ADDENDUM NO. 01

From: Craig A. Johnson, P.E.
Crist Engineers, Inc.

Date: January 13, 2023

Project: Wastewater Treatment Facility
Headworks Improvements
Paragould Light, Water, & Cable
Paragould, Arkansas

DEMOLITION PLAN D-1

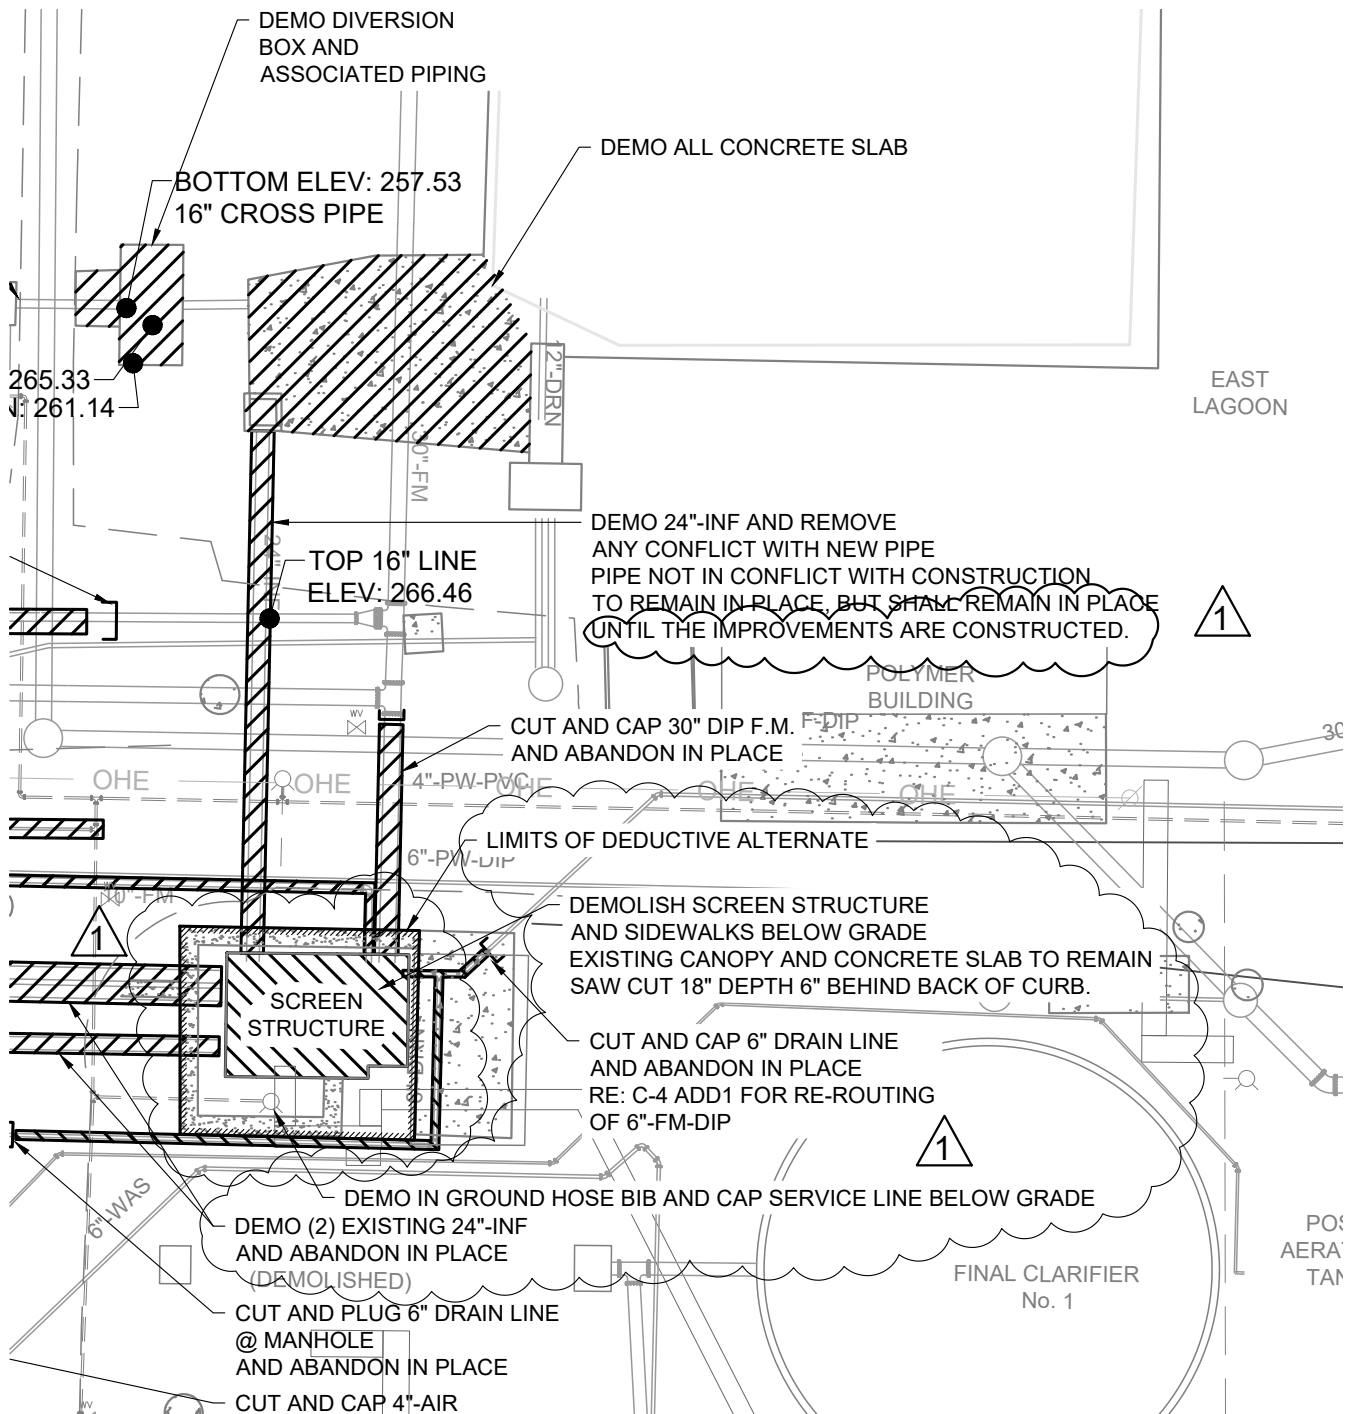
1. Drawing G-6 – Design Information:
 - a. Modify this drawing as shown on the Addendum No. 1 – Design Information, attached hereto.
2. Drawing D-1 – Demolition Plan:
 - a. Modify this drawing as shown on the Addendum No. 1 – Demolition Plan, attached hereto.
3. Drawing C-3 – Site Grading and Pavement Plan:
 - a. Modify this drawing as shown on the Addendum No. 1 – Site Grading and Pavement Plan, attached hereto.
4. Drawing C-4 – Yard Piping Plan:
 - a. Modify this drawing as shown on the Addendum No. 1 – Yard Piping Plan, attached hereto.
5. Drawing C-7 – Yard Piping 48-IN Overflow Plan:
 - a. Modify this drawing as shown on the Addendum No. 1 – Yard Piping 48-IN. Overflow Plan, attached hereto.
6. Drawing C-8 – Yard Piping 48-IN. Overflow Profile:
 - a. Modify this drawing as shown on the Addendum No. 1 – Yard Piping 48-IN. Overflow Profile, attached hereto.

HGL - FOUNDATION PLANS

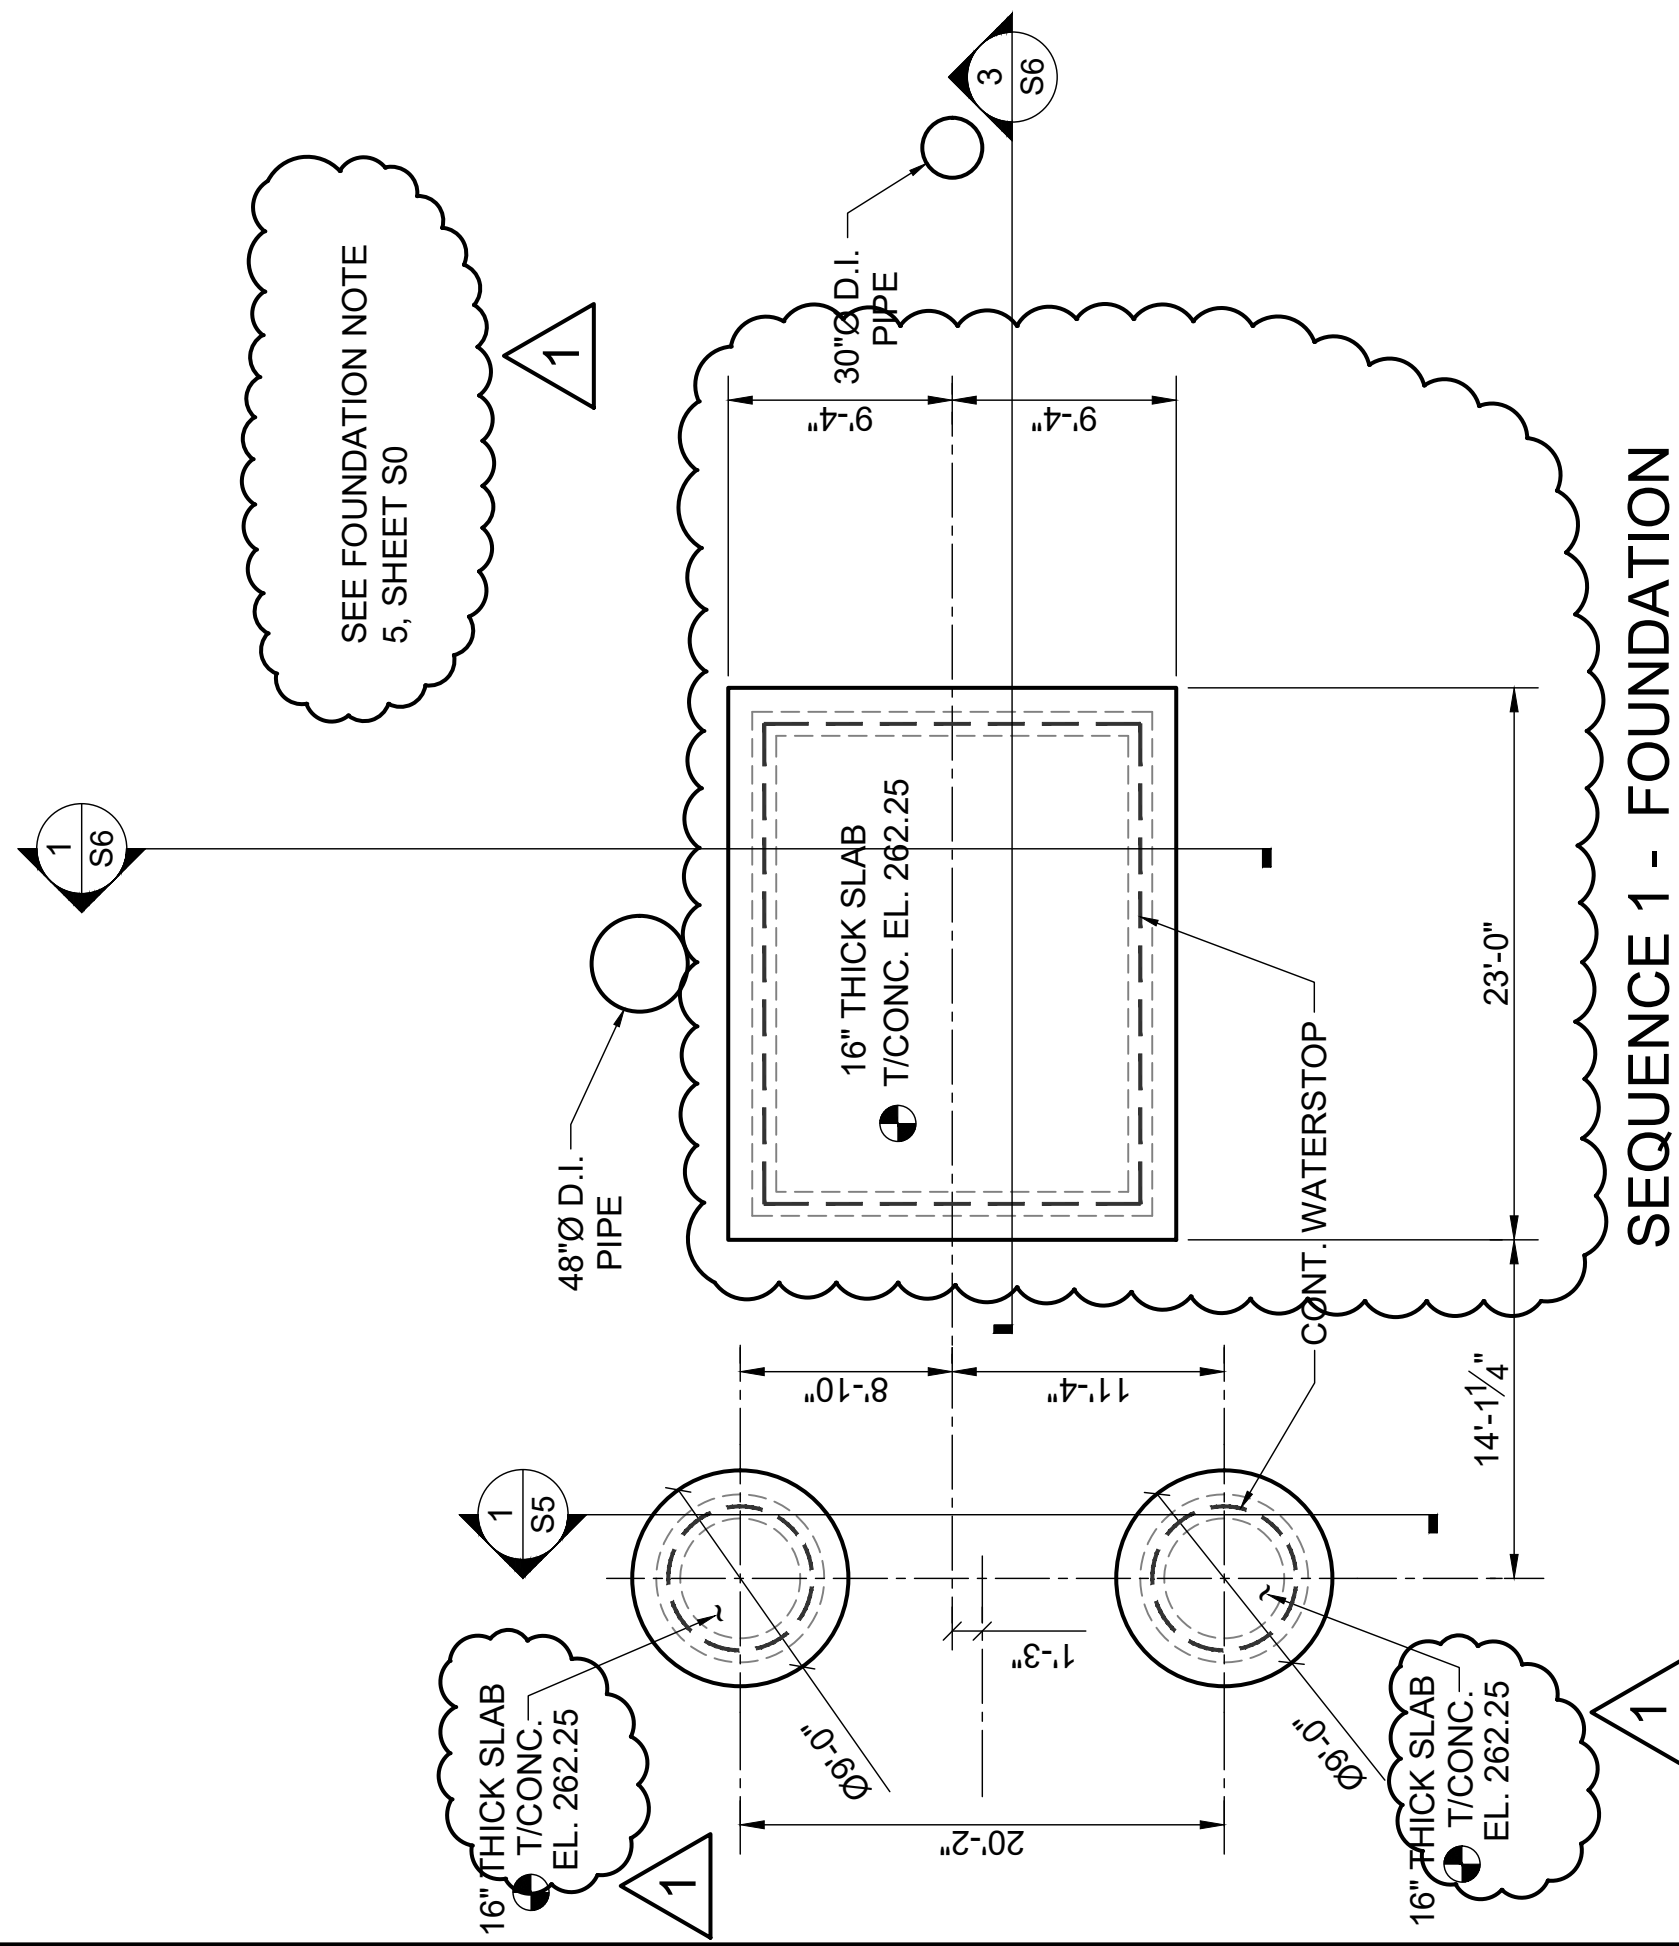
- a. Modify this drawing as shown on the Addendum No. 1 – Design Notes & Criteria, attached hereto.
9. Drawing S-1 – HGL – Foundation Plans:
 - a. Modify this drawing as shown on the Addendum No. 1 – HGL – Foundation Plans, attached hereto.

CREATED SEQUENCE 1 AND 1A
MOVED PORTION OF FOUNDATION
TO NEW SEQUENCE 1A - SEE SHEET S2

PISTAGRIT FLOOR BEAM
DETAIL B
1 1/2" = 1'-0"

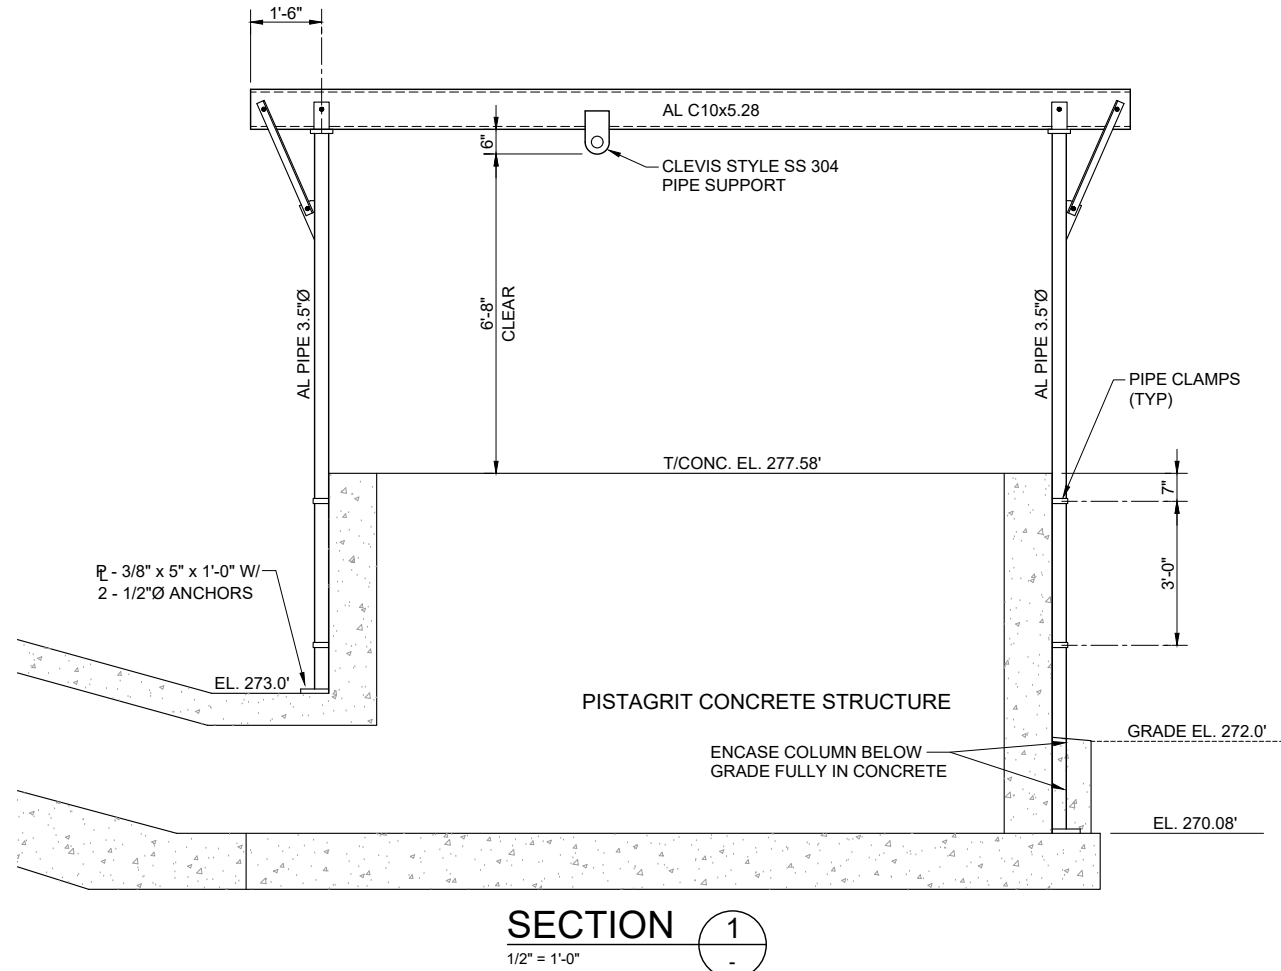
22. Drawing S-16 – PistaGrit Framing Details:
 - a. Add new Drawing Sheet S-16 as shown on the Addendum No. 1 – PistaGrit Framing Details, attached hereto.

1 ADDED NEW SHEET S16

EXTERIOR ALUM LADDER
DETAIL MZ-9 **B**
SCALE: 1" = 1'-0"

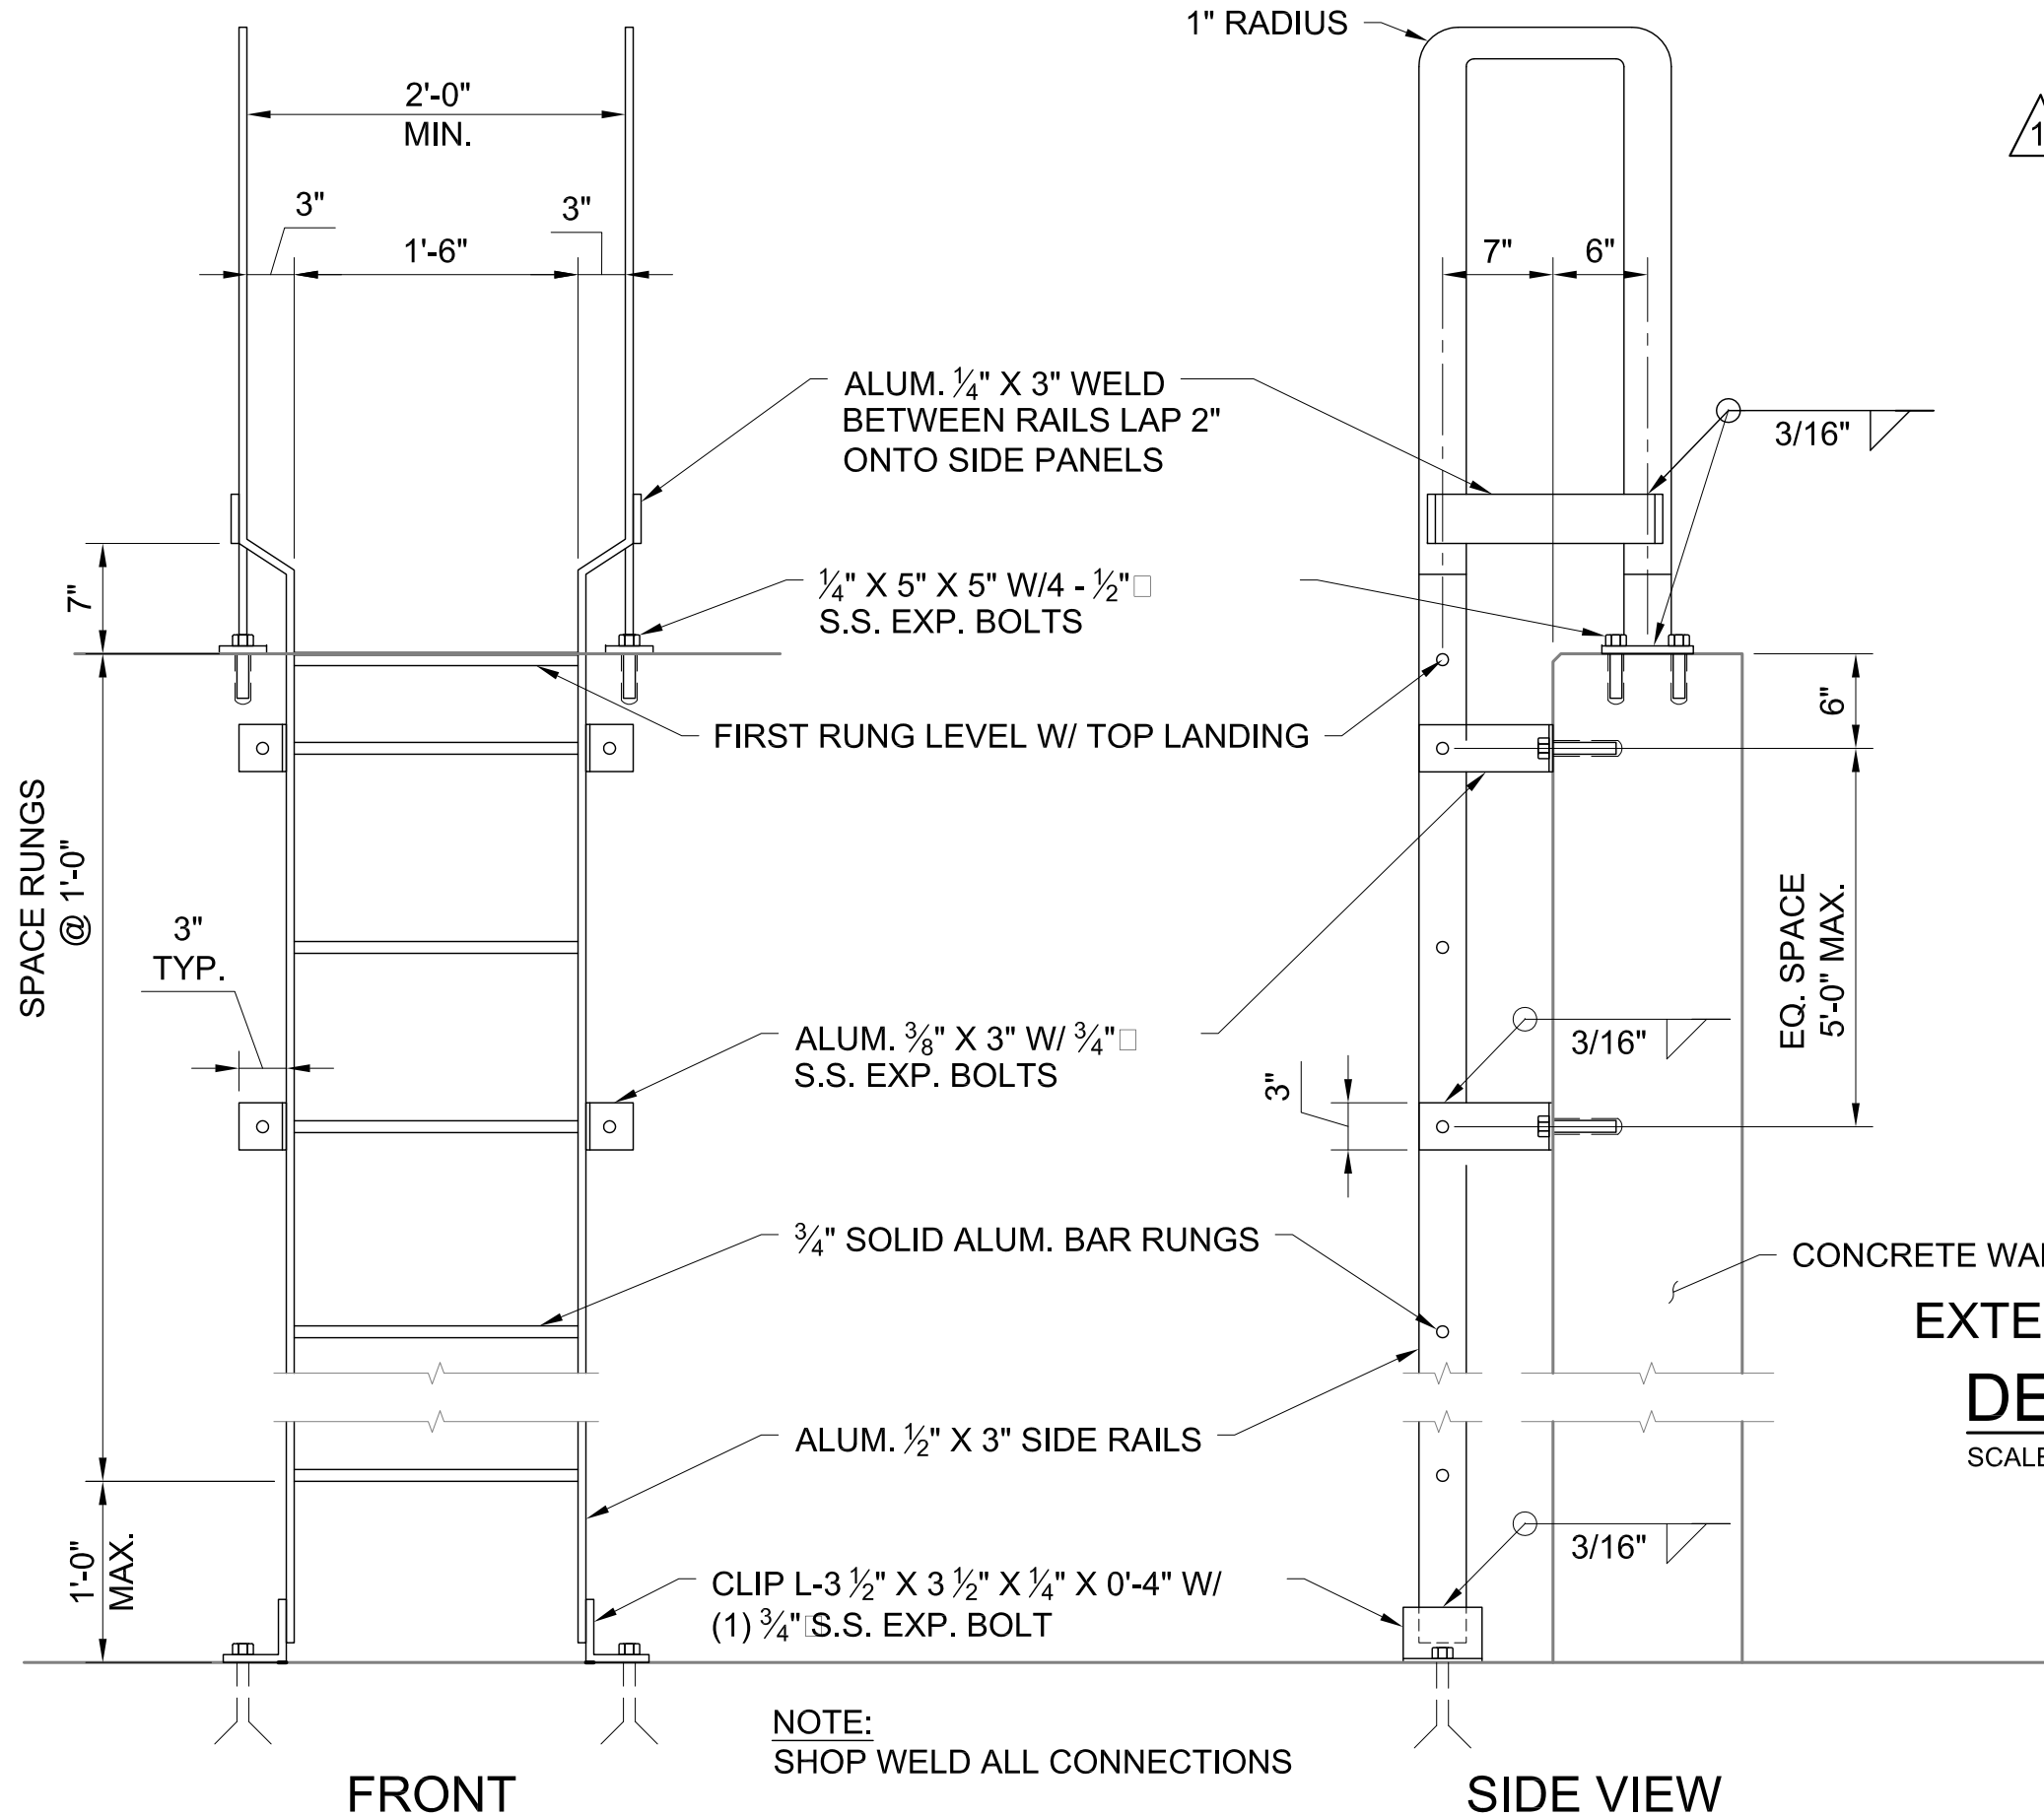
27. Drawing MZ-9 – Mechanical Standard Details IX:
 - a. Add new Drawing Sheet MZ-9 as shown on the Addendum No. 1 – Mechanical Standard Details IX, attached hereto.

1 THIS IS A NEW SHEET
